MODIFICATION INSTRUCTIONS for the

Kodak X-Omat MULTILOADER 300 Modification No. 37

Kodak X-Omat 270 RA PROCESSOR Modification No. 22

Kodak X-Omat 180 LP and 180 LPS PROCESSORS Modification No. 9

FIXER/WASH CROSSOVER - Drive Side

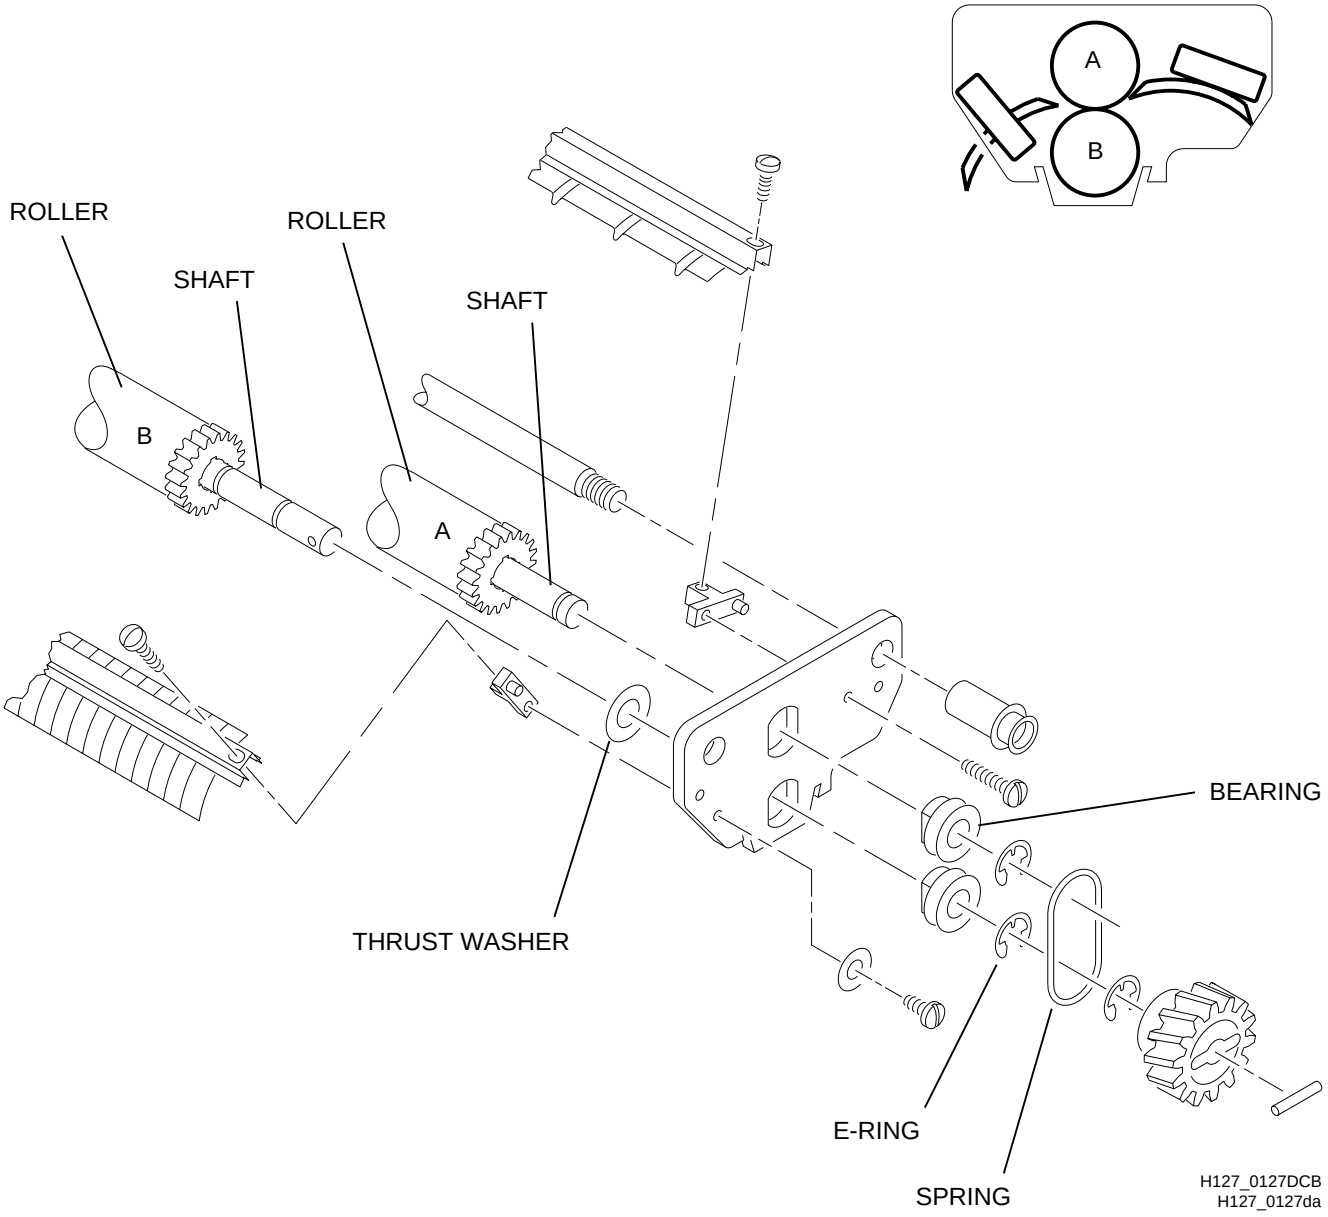
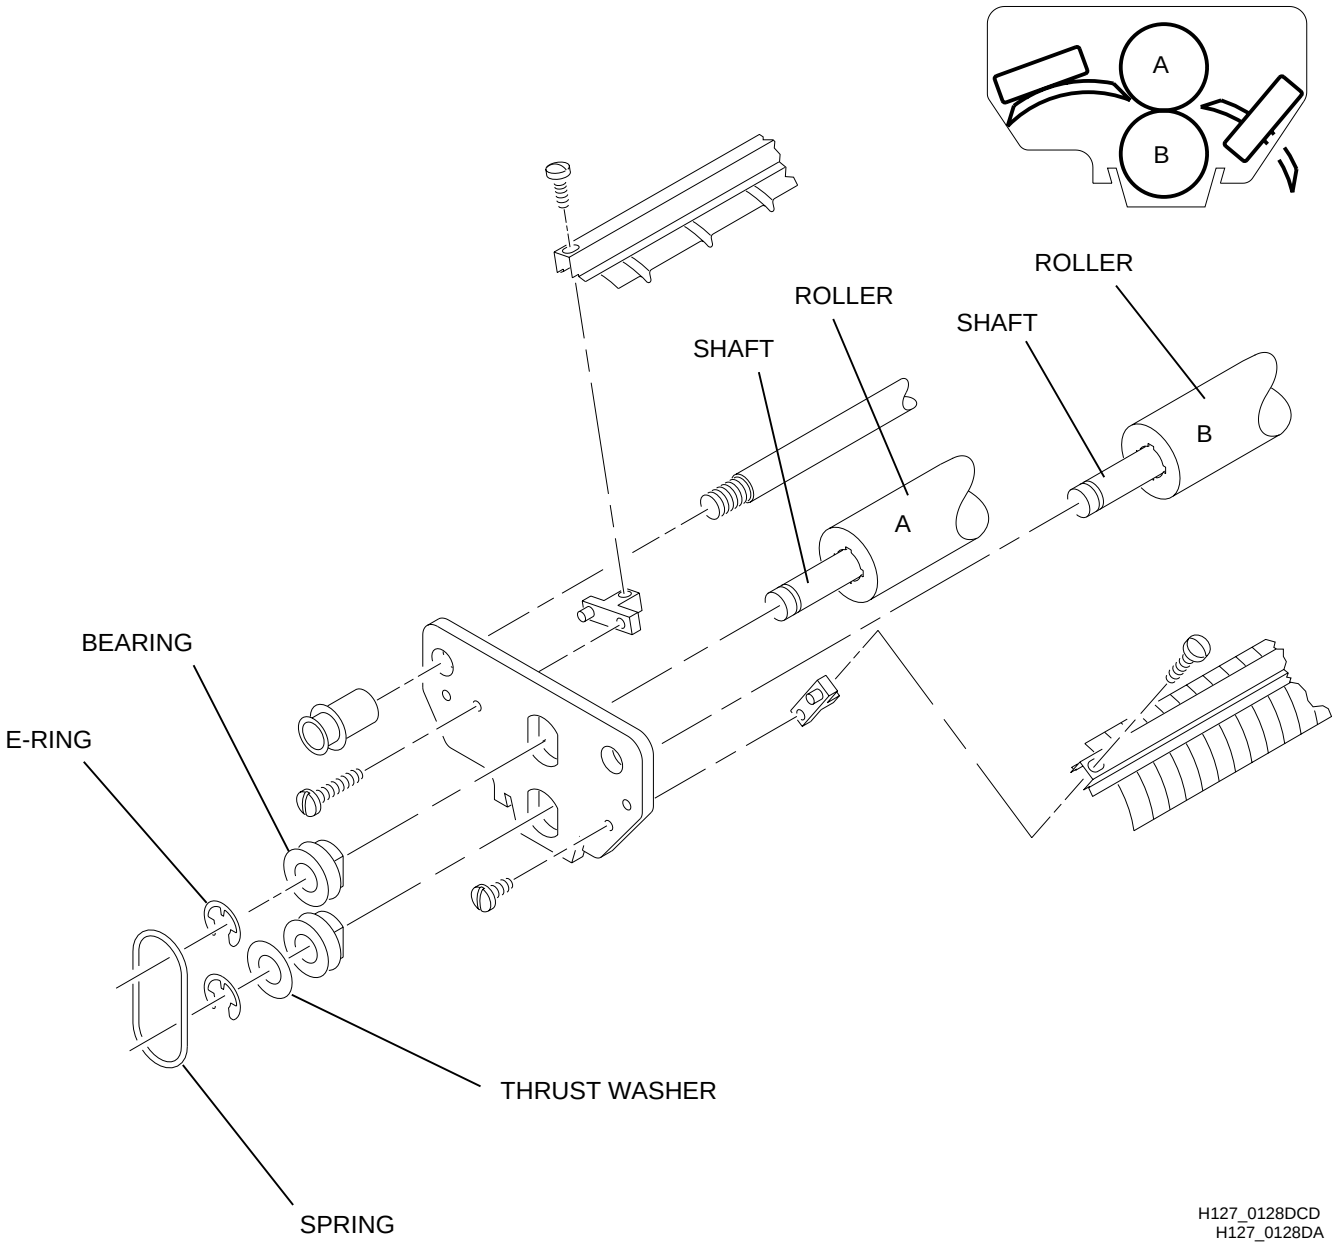
Purpose: To increase the reliability of the PROCESSOR by replacing the ROLLERS in the FIXER/WASH CROSSOVER. The replacement phenolic ROLLER has a steel core, which significantly reduces swelling, binding, and possible film transport problems. The mating rubber ROLLER is being replaced because the new ROLLERS are not interchangeable with the existing ROLLERS, and therefore must be replaced as a set. New BEARINGS and E-RINGS are also supplied.

1. Remove the FIXER/WASH CROSSOVER from the PROCESSOR
2. Remove the TROUGH, and save.
3. Remove the existing ROLLERS, BEARINGS, and E-RINGS, and discard. Save the SPRINGS, SHAFTS, and THRUST WASHERS.
4. Install the new ROLLERS, BEARINGS, and E-RINGS from the Mod Kit, using the SPRINGS, SHAFTS, and THRUST WASHERS saved in the previous step. Make sure that the THRUST WASHERS and other parts are assembled in the order shown.
5. Install the TROUGH.
6. Check the squareness of the RACK on a smooth, flat surface.
7. Install the FIXER/WASH CROSSOVER in the PROCESSOR.

Description	Old Part No.	New Part No.
Roller, Drive (black, rubber) [B]	594237	470085
Roller, Driven (phenolic) [A]	911660	9B8662
Fixer/Wash Crossover Assembly	918945	9B8445
